INVESTIGATION REPORT FORM (IRF)

Customer: MITSUMI PHILIPPINES INC.

Item Description: 19-Y926 A DRT-J583 CARTON BOX-R

Nature of Defect:
 POOR PRINT

ILLUSTRATION OF THE PROBLEM

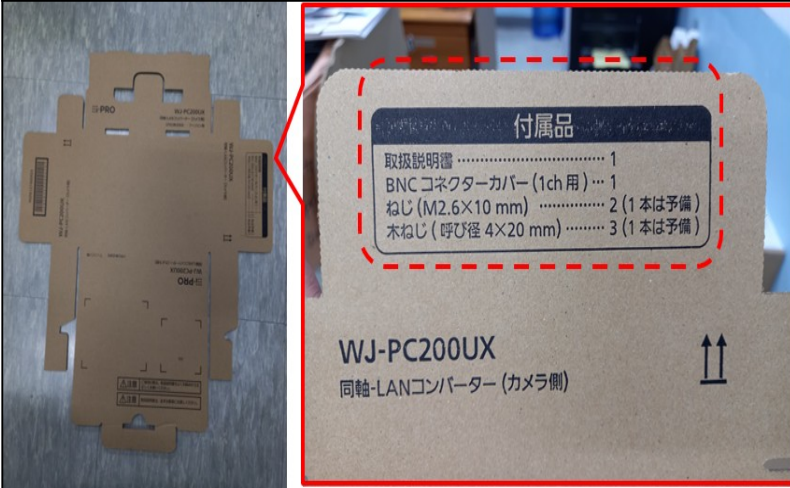
Requirement:
 NO POOR PRINT

Actual:
 WITH POOR PRINT

WHY 1 : uneven distribution of ink to the substrate

WHY 2 : inconsistent board thickness

WHY 3 : incorrect nip pressure

WHY 1: Cascade to EQOs Operators to conduct mandatory set up checks before mass pro and continuous quality inspection during the run
